Letter of Permissive Change

Subject: Permissive Change for FCC ID: BEJ-WL1BKT23

This is to request Permissive Change for FCC ID: BEJ-WL1BKT23, Originally Granted on 03/09/2023.

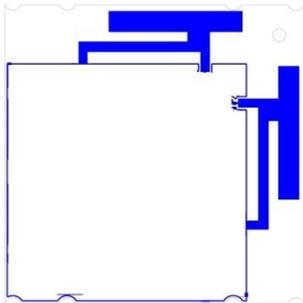
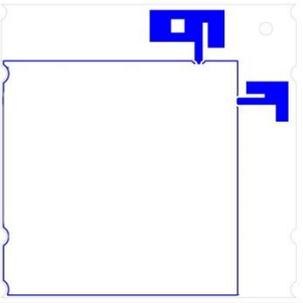
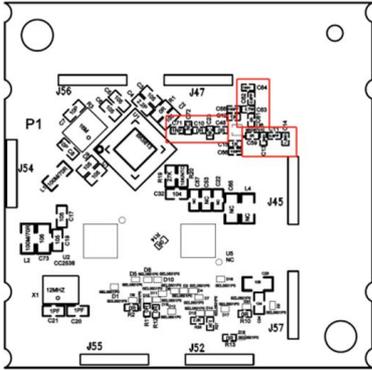
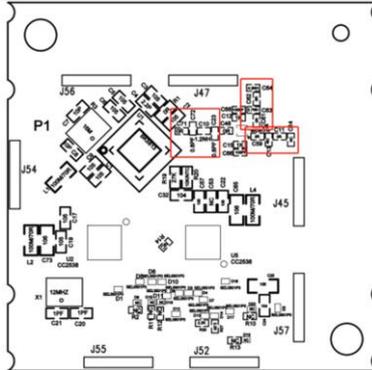
Change: The difference compared with the original is added Frequency by Software and decrease power from the power setting configuration via software change and the RF circuit is identical.

Item	Original	Permissive Change
Model	WL1BKT23	WL1BKT23
Frequency	U-NII Band 3: 5730-5848MHz.	To add Frequency by Software. U-NII Band 1: 5155-5245MHz U-NII Band 3: 5730-5848MHz
Software Version	V1.1	V1.6
Hardware version	V1.3	V1.6
Antenna Shape.		To change Antenna Shape. 
Components	Original	To change Internal Components are mainly for the new Antenna Shape (C71, C72, C10, C23, C62, C64, C13, C11 and C14) Please see as below red mark.
